Access Compliance Report

Public Rights-of-Way

(Curb Ramps)

Intersection ID: 47841	Main Street: MANITOBA_LN	Cross Street: ALVARADO_WY	Location: NE
ADA ID: FCBA0D935009	Ramp Type: PerpDiag	Initial Pass/Fail: Fail	Overall Compliance: No
Severity Score: 33.75			
Codes/Mitigation Info/Possible Solution		Field Measurements/Component Compliance

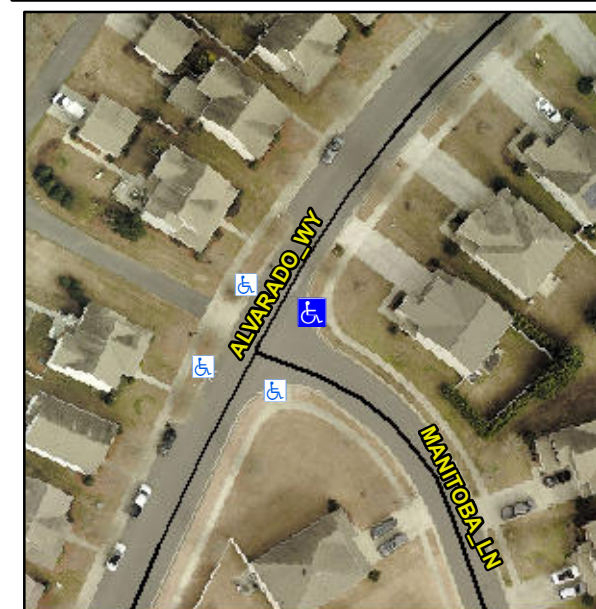
Not Found, R304.5.1, R304.2.2, R304.5.3

Compliance	Description	Data	Compliance	Description	Data
N/A	Ramp Length (in)	77.0	No	Ramp Slope (%)	11.2
No	Ramp Width (in)	47.0	No	Ramp XSlope (%)	5.1
N/A	Flare Type LT	N/A	N/A	Flare Type RT	N/A
N/A	Flare Slope LT (%)	N/A	N/A	Flare Slope RT (%)	N/A
N/A	Flare Traversable LT?	N/A	N/A	Flare Traversable RT?	N/A
N/A	Landing Length (in)	N/A	N/A	DWS Provided?	N/A
N/A	Landing Width (in)	N/A	N/A	DWS Contrast?	N/A
N/A	Landing Slope (%)	N/A	N/A	DWS Length (in)	N/A
N/A	Landing X Slope (%)	N/A	N/A	DWS Full Width?	N/A
N/A	Landing Curb? (Y/N)	N/A	N/A	DWS Offset (in)	N/A
N/A	Shared Landing?	N/A			
N/A	Gutter Ponding?	N/A	N/A	Gutter Slope (%)	N/A
N/A	Gutter Lip Ht (in)	N/A	N/A	Gutter X Slope (%)	N/A
N/A	Painted X Walk1?	No	N/A	Painted X Walk2?	No
	X Walk 1 Direction	To NW		X Walk 2 Direction	To SW
N/A	X Walk 1 Width (in)	N/A	N/A	X Walk 2 Width (in)	N/A
	X Walk 1 Slope (%)	2.3		X Walk 2 Slope (%)	0.5
	X Walk 1 X Slope (%)	1.9		X Walk 2 X Slope (%)	2.6

Remove & Replace Curb Ramp With Two New Directional Ramps or Equivalent.
